PROPOSAL

JOB NAME: VFD FP-3-1 KW Sewer Plant

Key West VFD Replacement

Additional Unforeseen Conditions

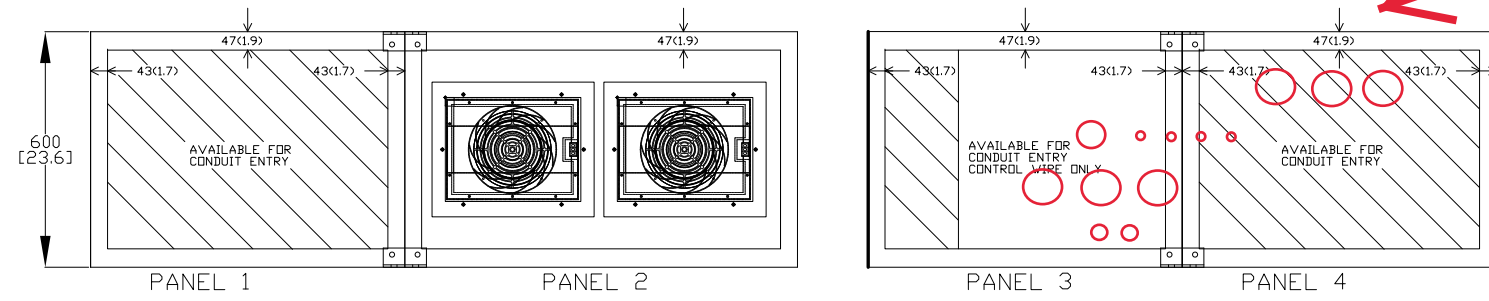
- 2) We cannot reuse the wire from the existing iso. transformer to the existing VFD because the new pulse transformer feeds the new VFD through four high stranded 1000 volt DC cable. Factory cables are not long enough.
 - a. Solution, we are going to have to purchase new 1000v DC Cable. See pic#3

Factory DC high voltage cable, intended to be installed from Pulse Xformer to New VFD, but it is not long enough.

DIMENSION DRAWING
ITEM 0001
EFFLUENT PUMP P-6-2-1
Drawn by: PS Date: 4/4/19

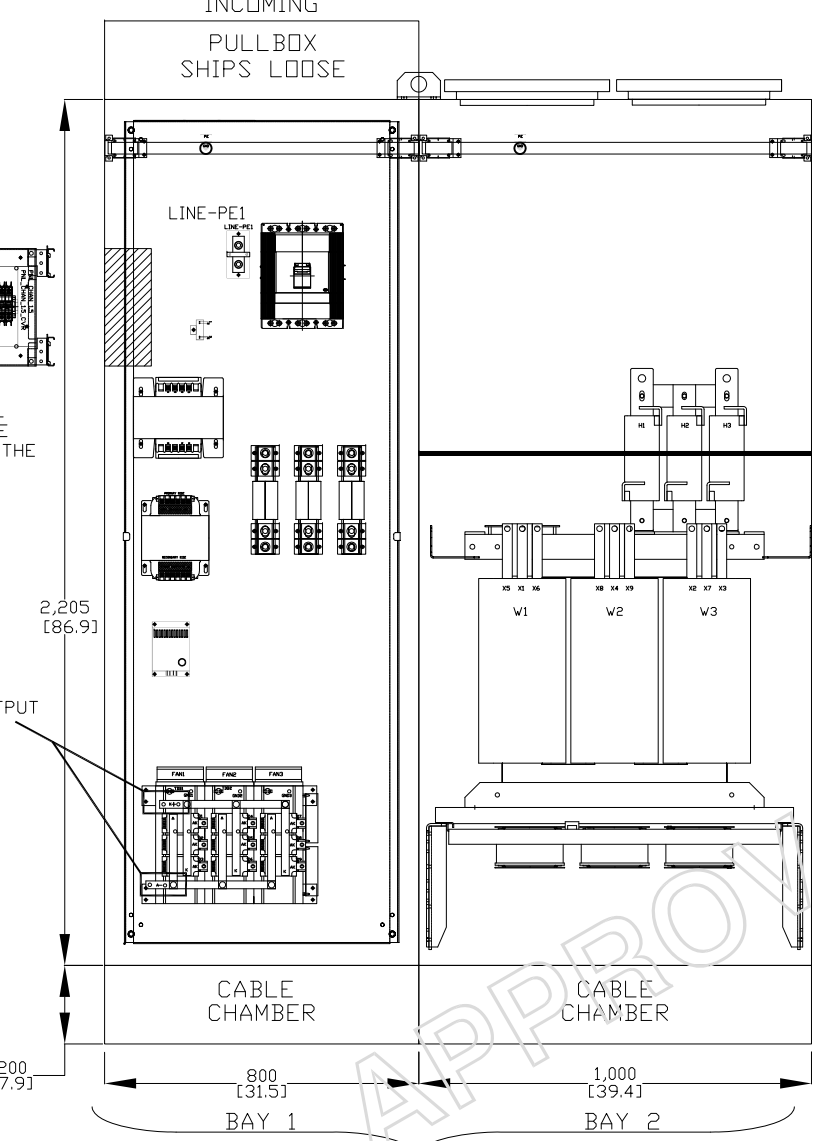
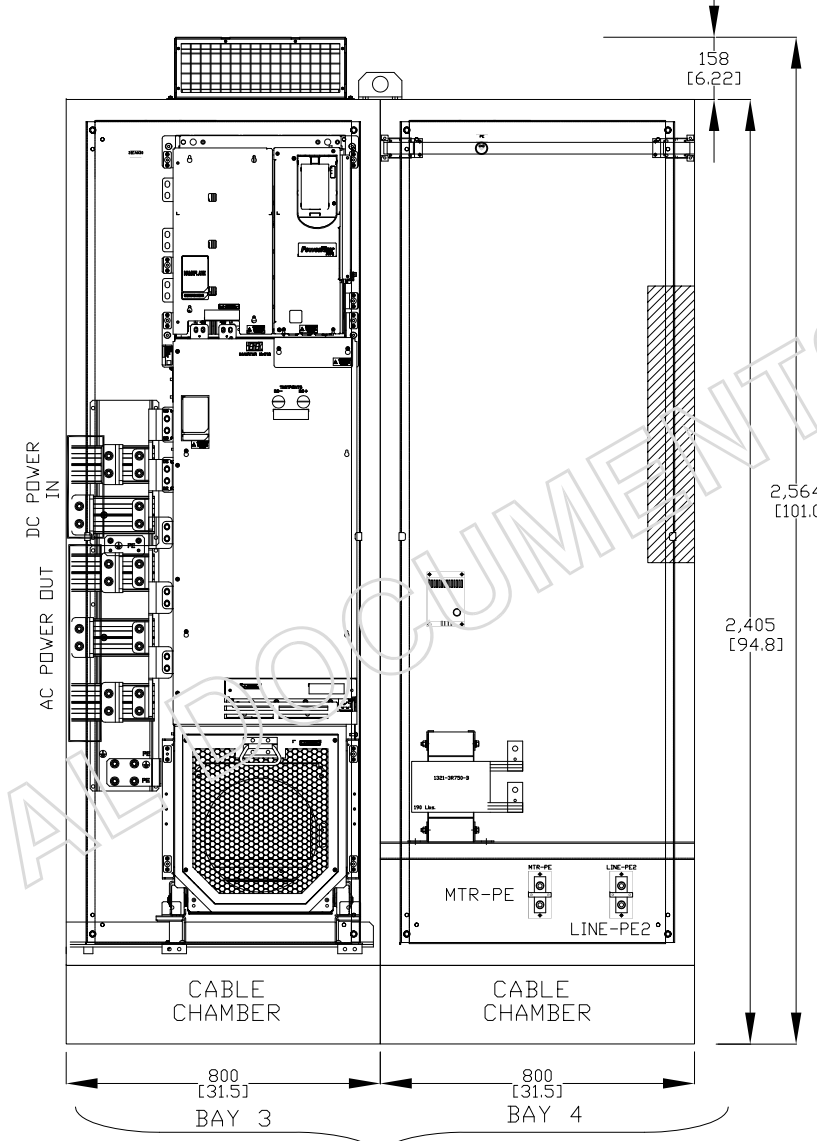
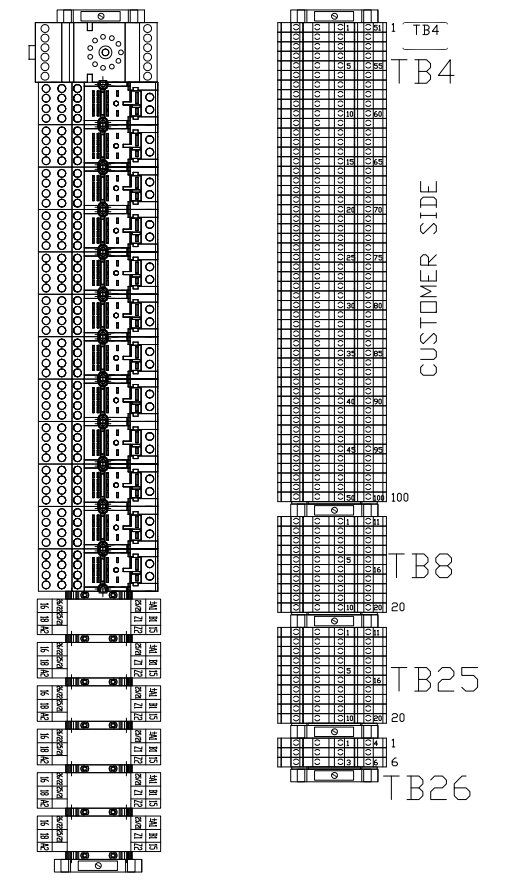
- 3) The conduit arrangement above the existing VFD will not fit in the new VFD window. See pic#4
 - a. Solution, cut the conduit close to the ceiling and install grounding bushing and free wire to the new VFD window. (as done previously) We will have to install "C" condilets to accommodate pulling wire back. See pic#5

Existing conduit layout will not fit into new conduit window

Cut existing conduit and install grnd bushing then free wire to new VFD, as done previously

Install "C"
Condilet

Install
Compression
Male Adapter

Mechanically
Cut Coupling
